Title: 2013-14 N13 Cylinder Pack - Update for Excessive Lubrication Oil Consumption

Applies To: 2013-14 N13 ESN: 4300000-4315712

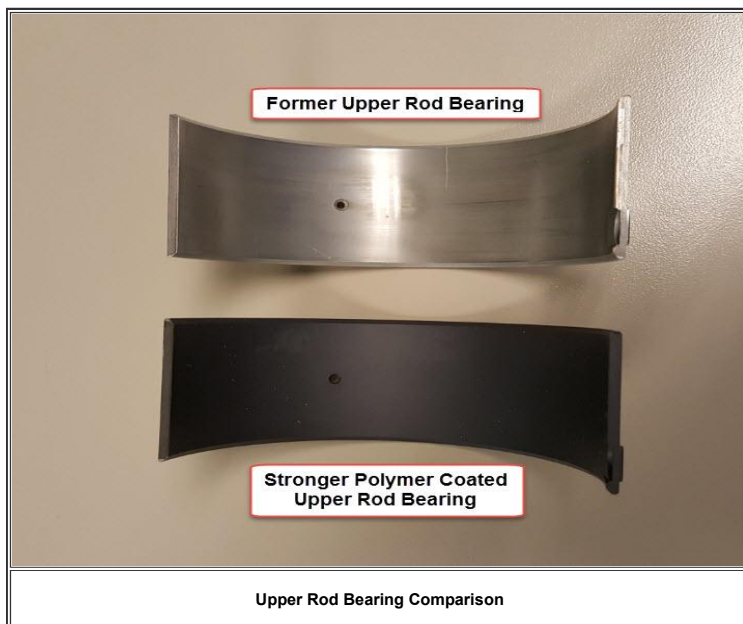
On certain N13A engines serial numbers ranging from **4300000 - 4315712**. Carbon can build up on the top lands of the pistons and cause the piston rings to stick leading to loss of oil control in the power cylinders and increased oil consumption.

An updated cylinder kit is now available to address this condition. The updated liner integrates a removable "anti-polish" carbon scraping ring which sits in a machined counterbore. This anti-polish ring (APR) has a smaller internal diameter than the rest of the liner that allows it to scrape carbon off of the top land of the piston during normal operation. This action of continuously removing carbon buildup from the top land of the piston prevents the rings from carbon packing and losing oil control in the power cylinders.

Follow: [2013 N13 Engine Service Manual](#) for base engine repairs.

13L connecting rod bolt torque is CRITICAL. Lightly lubricate the underside of the new rod bolt head and threads with clean 30W engine oil. Follow the torquing procedure EXACTLY as written in the latest Service Manual using a calibrated torque wrench
